**To:** Members of Dublin City Council  
**From:** Marsha I. Grigsby, City Manager *MIG/Sg*  
**Date:** September 20, 2012  
**Initiated By:** Steve Langworthy, Director of Land Use and Long Range Planning  
**Re:** Final Plat - Wellington Reserve (Case 12-034FDP/FP)

This is a request for review and approval of a final plat for 17.9 acres, 28 single-family lots, right-of-way and 3.5 acres of open space for the Wellington Reserve development, located on the north side of Brand Road, approximately 750 feet east of the intersection with Coffman Road.

**1. Wellington Reserve PUD 5144 Brand Road**  
**12-034FDP/FP Final Development Plan/Final Plat**

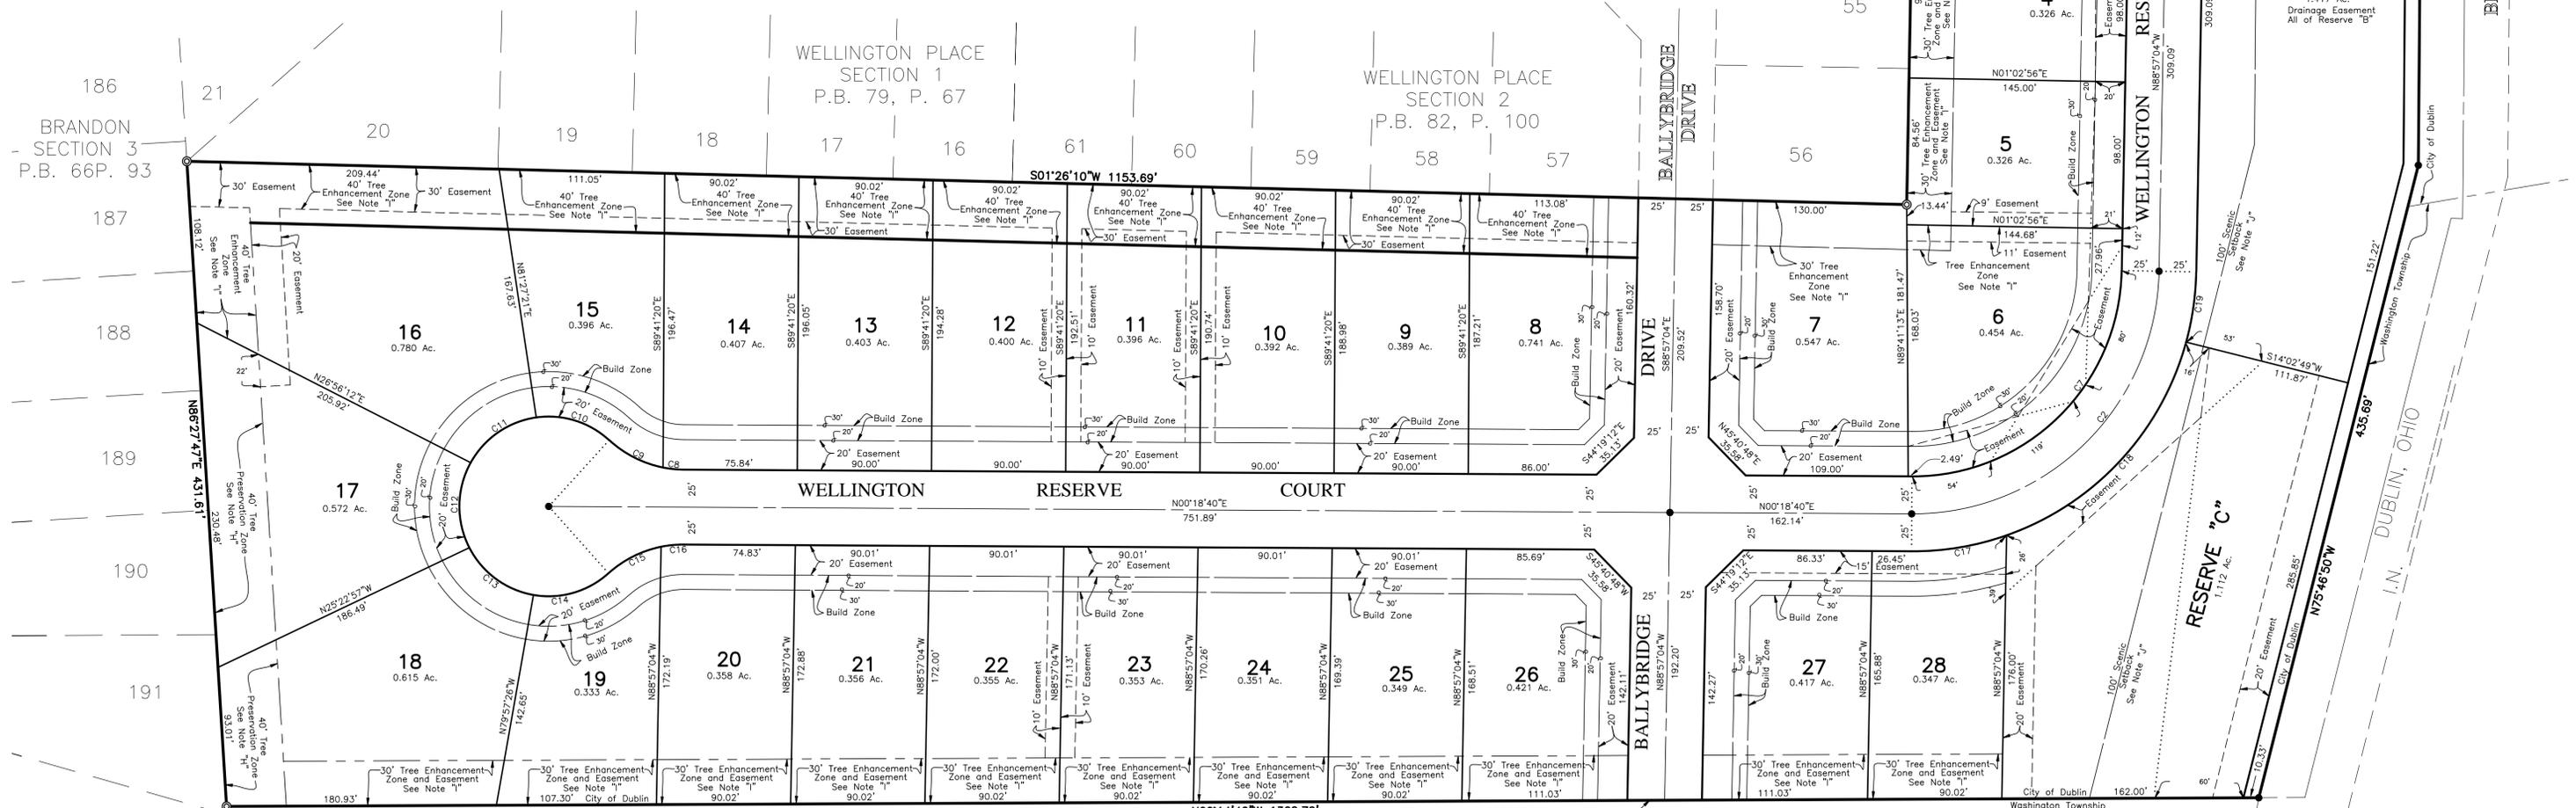
- 1) That the final plat be revised to indicate the Tree Enhancement Zone and rear yard setback on each lot;
- 2) That the final plat be revised to not assign side yard setback numbers for Lot 6;
- 3) That plat notes "H" and "I" regarding the Tree Preservation and Tree Enhancement Zones include the maintenance responsibilities for these areas; and
- 4) That the plat notes be revised to accurately reflect open space ownership.

# Proposed Final Plat

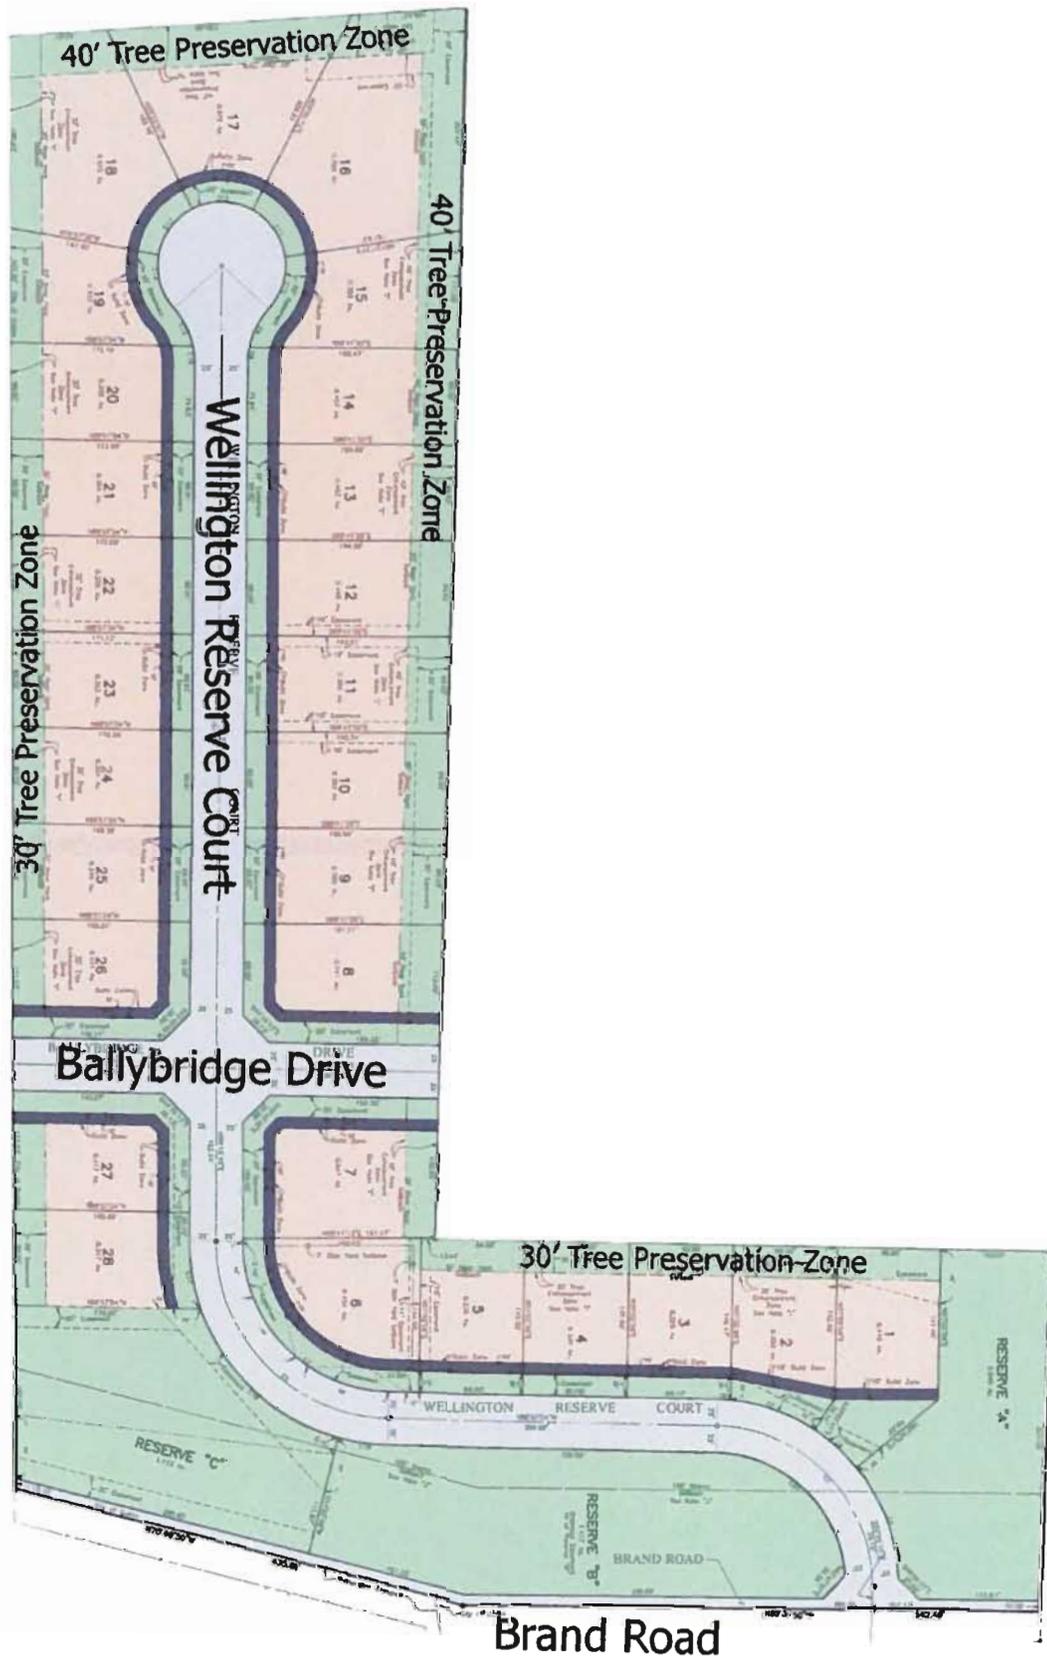
- 1) That the final plat be revised to indicate the Tree Enhancement Zone and rear yard setback on each lot;
- 2) That the final plat be revised to not assign side yard setback numbers for Lot 6;
- 3) That plat notes "H" and "I" regarding the Tree Preservation and Tree Enhancement Zones include the maintenance responsibilities for these areas; and,
- 4) That the plat notes be revised to accurately reflect open space ownership.

The Commission reviewed this final plat together with the final development plan on August 23, 2012. The Commission recommended approval to City Council of the final plat with four conditions, all of which have been met:

# Proposed Entry Feature

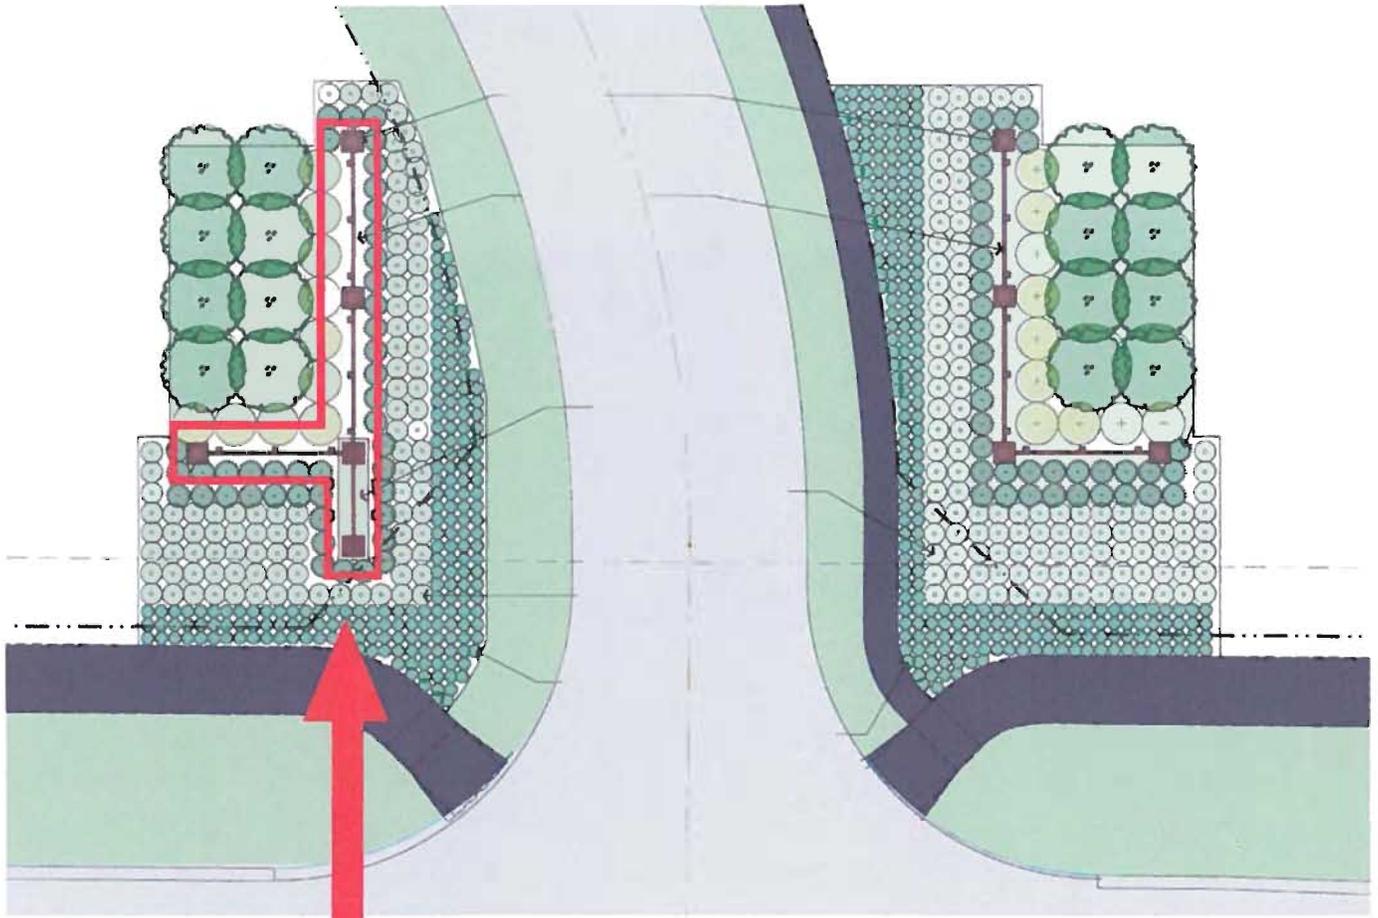
- 2) That the plans indicate the material of the sign panel; prior to scheduling the final plat for City Council review;
- 3) That the final development plan indicate lawn to be maintained by the HOA within the potential extension of Ballybridge Drive and include a sign detail indicating a potential future road extension, subject to Planning approval, prior to scheduling the final plat for City Council review;
